UNITED STATES PATENT AND TRADEMARK OFFICE

APPLICATION NO.	FILING DATE	FIRST NAMED INVENTOR	ATTORNEY DOCKET NO.	CONFIRMATION NO.
10/719,478	11/21/2003	Takashi Suzuki	051319/0076	3623

Office Action Summary

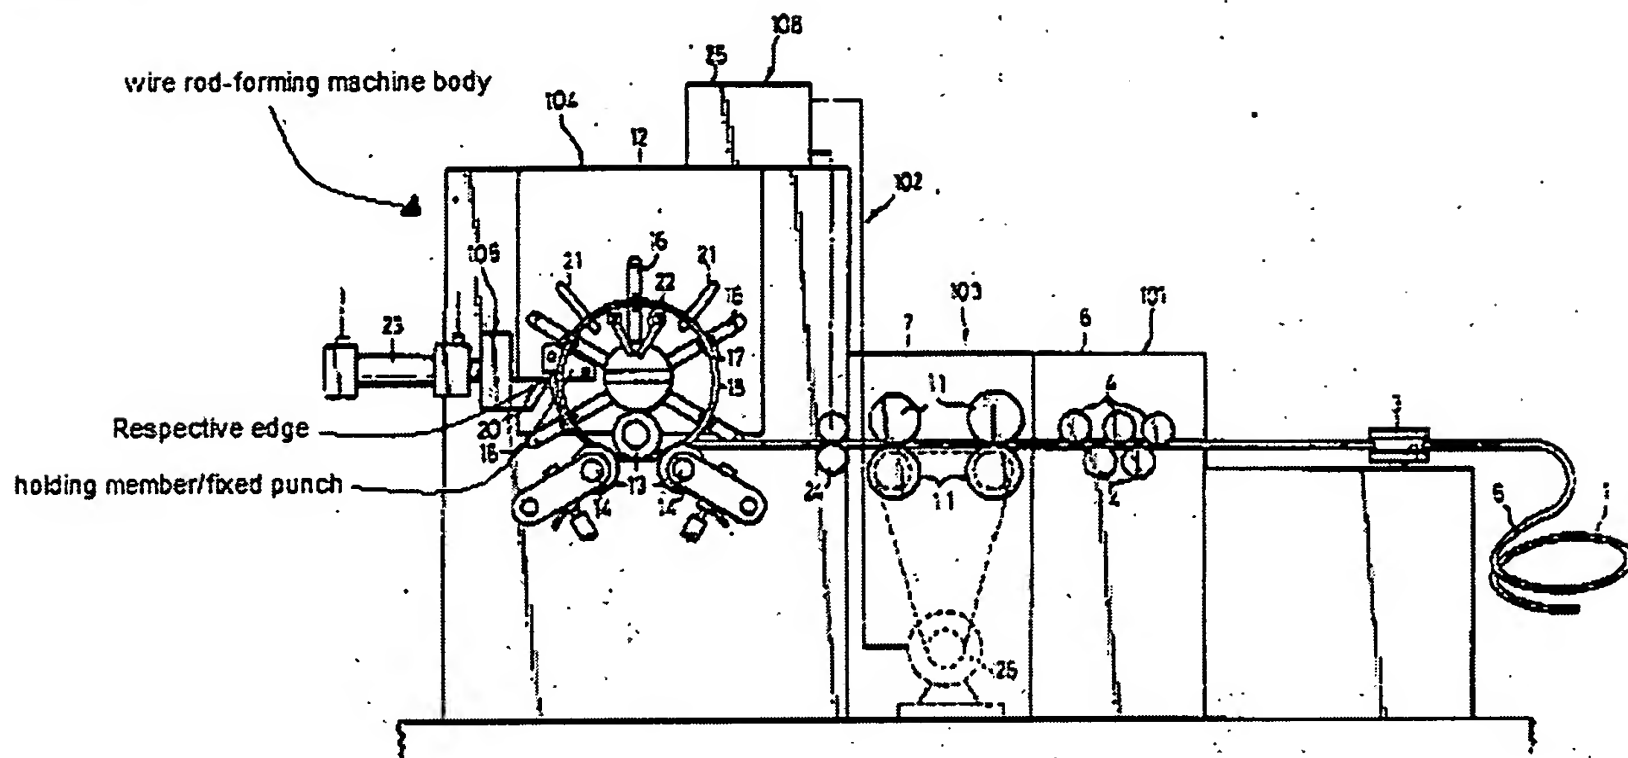
1. Claims 1-3 are rejected under 35 U.S.C. 102(b) as being anticipated by Yoshioka (U.S. Patent # 4,823,576). Yoshioka discloses an apparatus for manufacturing ring-shaped member from elongate work piece having a wire rod-forming machine body (See FIG below), bending rollers (13) for shaping a wire rod into a ring shape, a cutting member (cutting means 105) having a respective edge (blade 20) that moves in a horizontal direction in the wire rod-forming machine body and cuts the wire rod therefore separating the shaped part from the unshaped part, and a holding member/fixed punch having a respective edge (See FIG below) is crossed by the cutting member (cutting means 105) and allows the ring to be moved once it is cut by the cutting member (cutting means 105).
